STATE OF NORTH CAROLINA
DEPARTMENT OF TRANSPORTATION

February 15, 2012
Revised March 15, 2012

SUBJECT: **Application for Section 404 Individual Permit, Section 401 Individual Water Quality Certification, and Randleman Lake Buffer Authorization** for the proposed improvement of Greensboro-High Point Road (SR 1486-SR 4121) from US 311 Bypass (future I-74) in High Point to Hilltop Road in Greensboro, Guilford County, Division 7. Federal Aid Project No. STP-4121(1), State Project No. 8.2491602, WBS Element No. 34802.1.1, TIP No. U-2412A&B/U-2524AE.

SITE 5 AND 6 PLAN VIEW

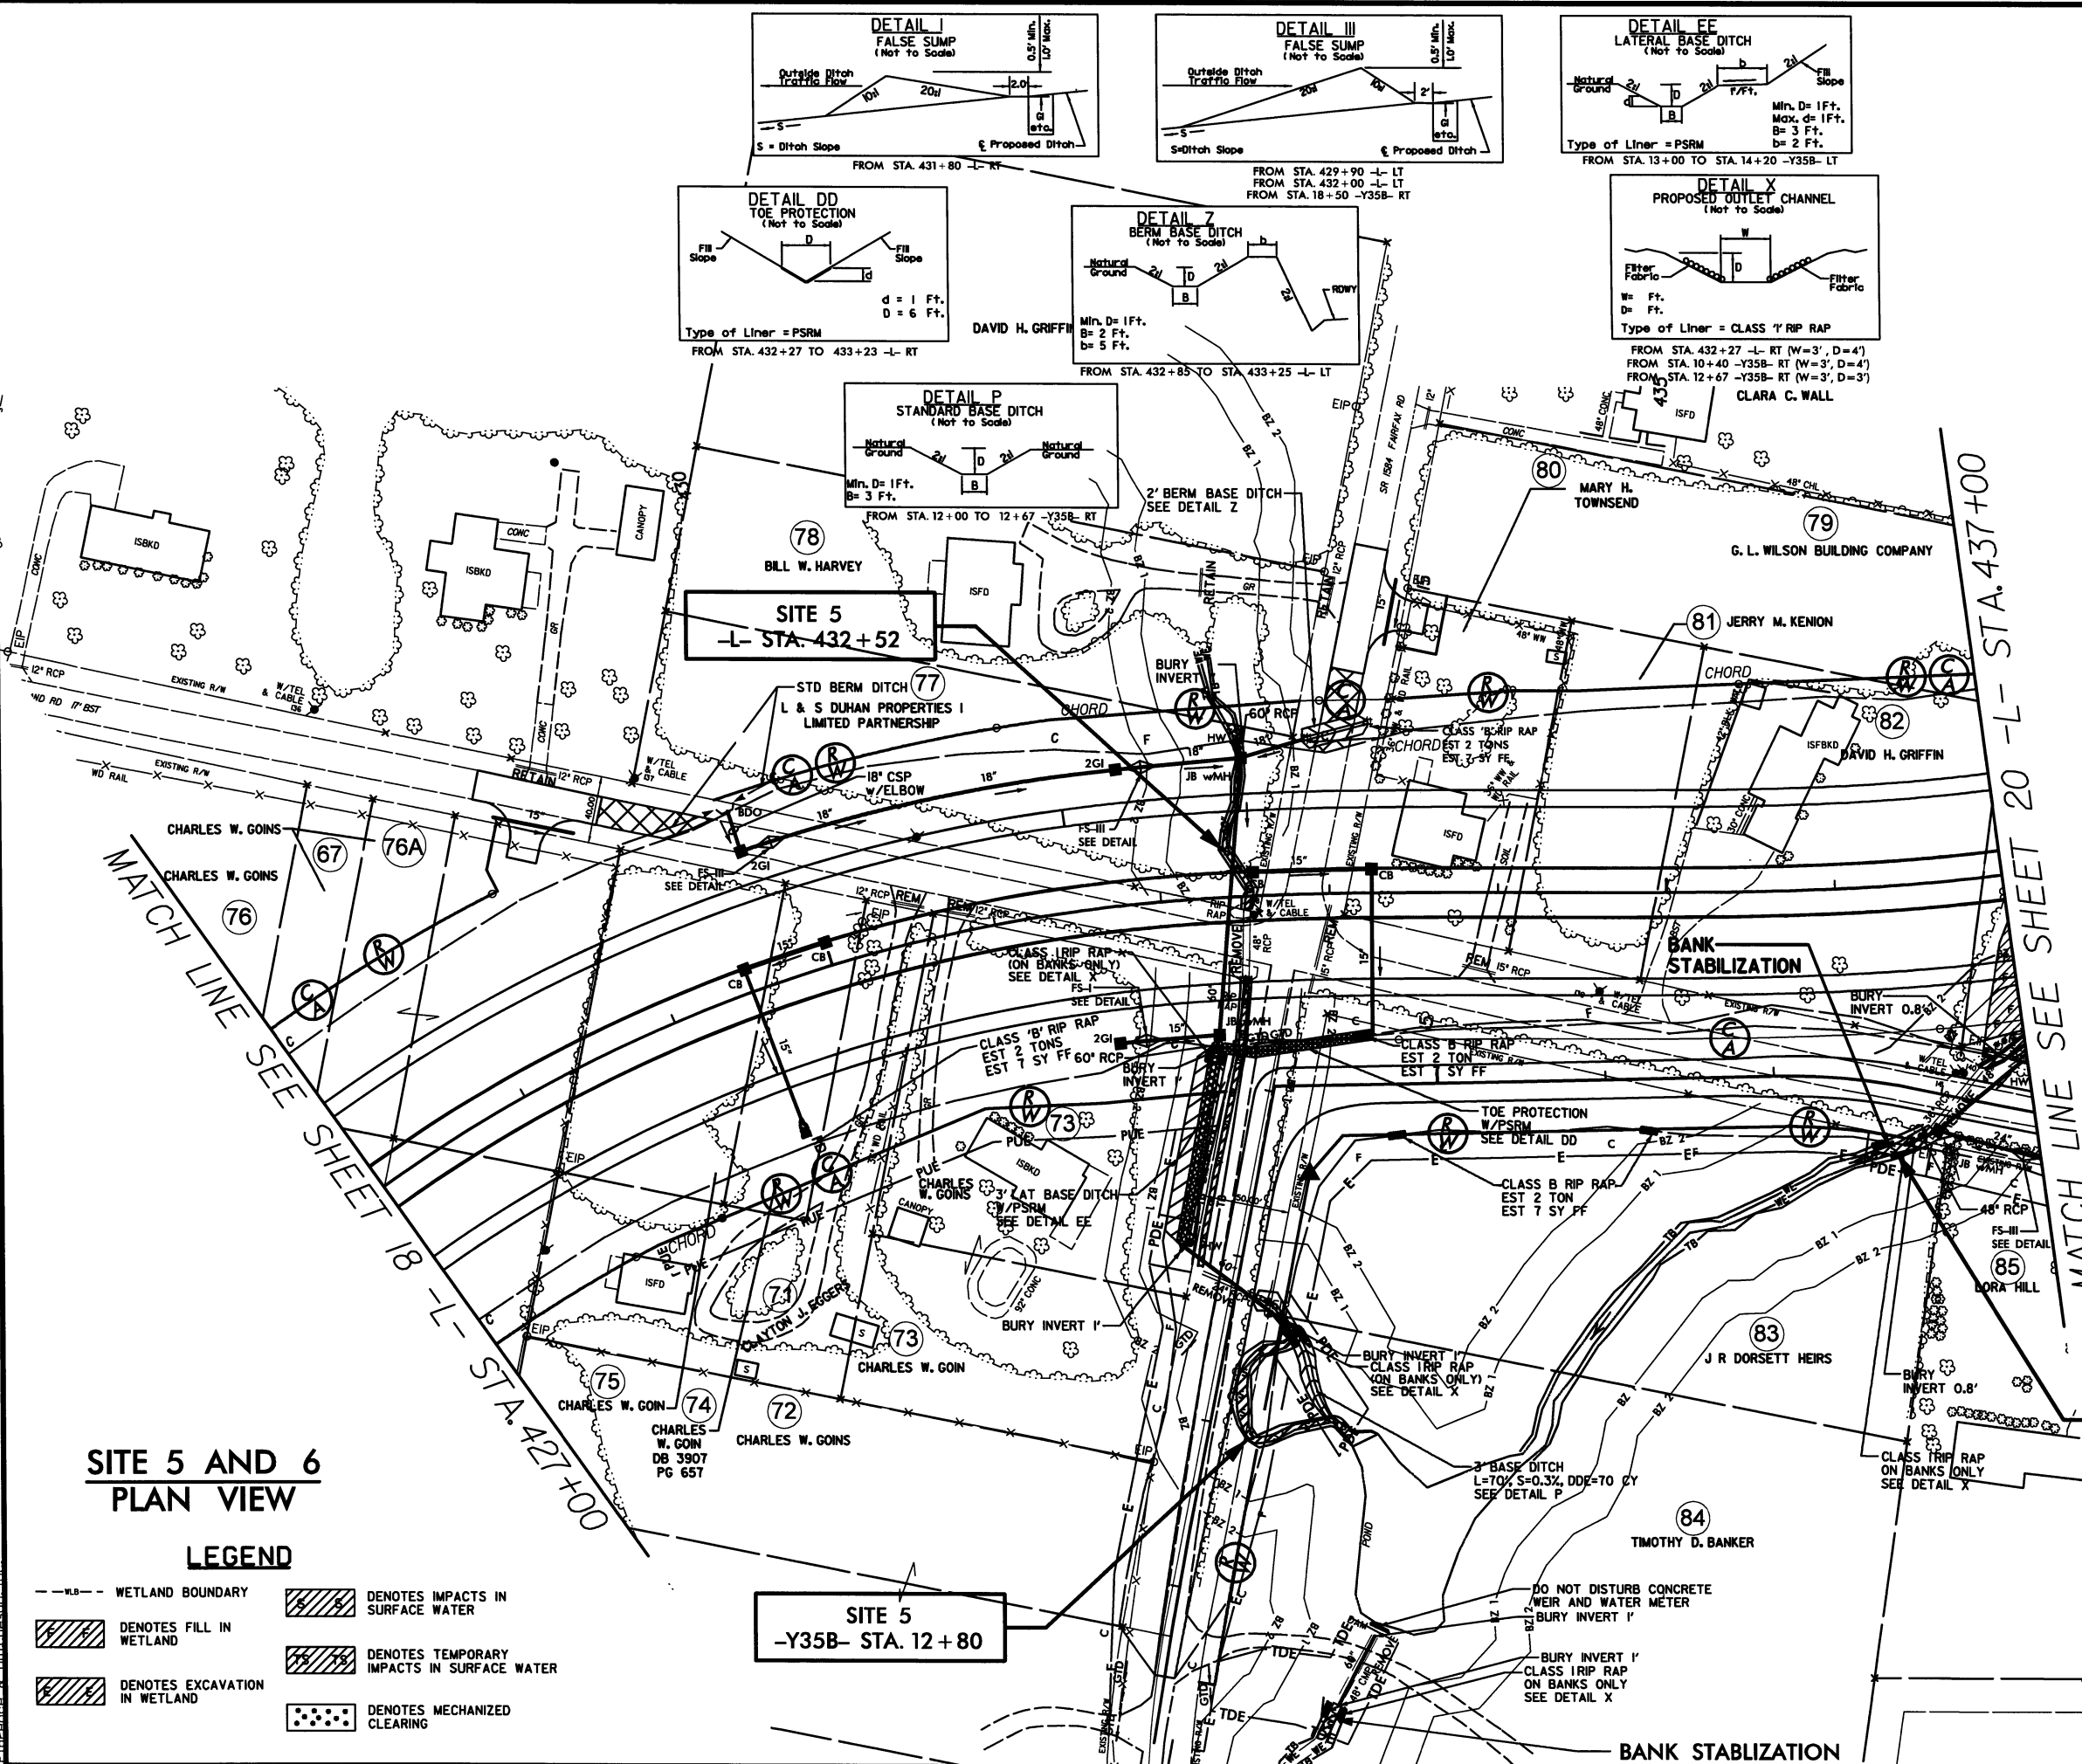
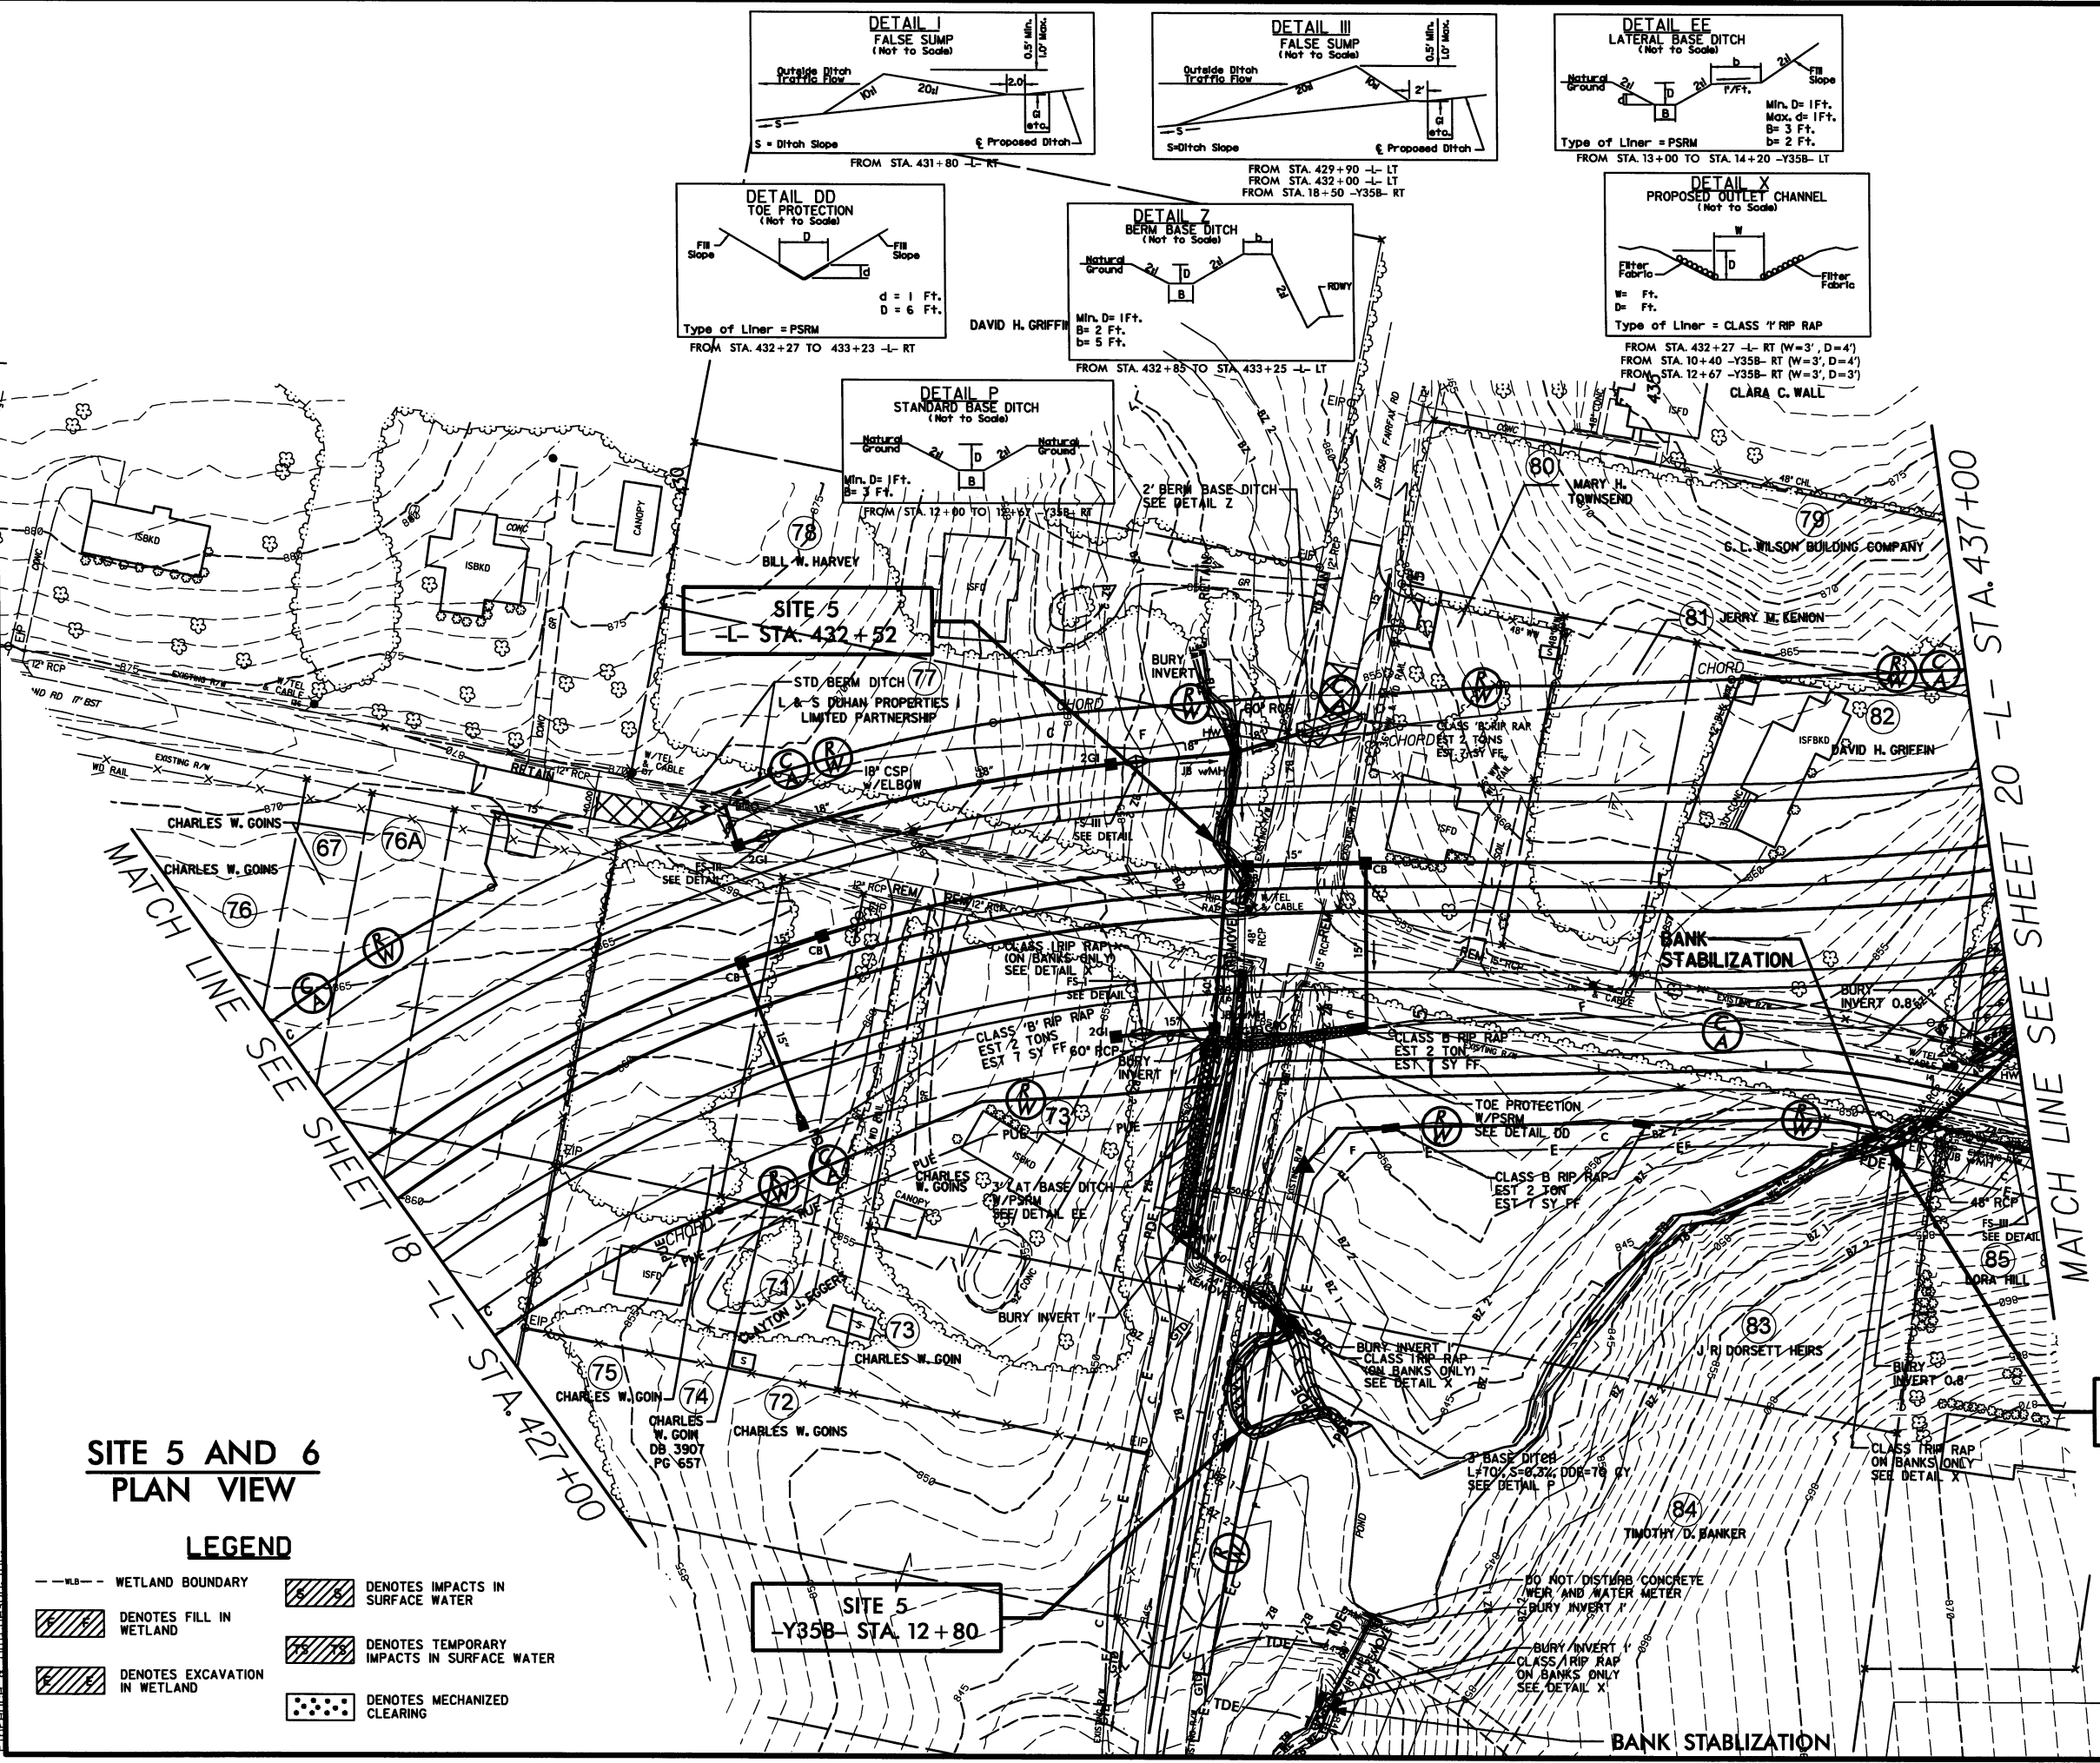
1. Combine Site 7 with Site 8 and label as Site 5 since they are along the same stream.
2. For Site 8, F&H should coordinate with Hydraulics Unit to verify if the existing gravel road (Fairfax Road) is NCDOT maintained transportation facility to determine if buffer limits end at existing road's toe of fill.

1. Combine Site 7 with Site 8 and label as Site 5 since they are along the same stream.
2. For Site 8, team discussed the best way to provide stability for erosion & sediment control to construct the stream relocation along SR 1584 (Fairfax Road) and at the same time, maintain continuity of stream features during construction.

3. For Site 8, NCDOT proposes to remove trees only as necessary to install the cross pipe, associated tail ditch and the new driveway pipe. ~~Team discuss the best way to convey this to the Contractor.~~ After discussion with Construction, it has been determined it's better not to drain the pond but access the driveway pipe parallel the drive on the downstream side. A note will be added to the plans-"Do not disturb existing weir". Water can be pumped around while the pipe work is being done. The TDE and impacts to the buffers around the pond will be removed.
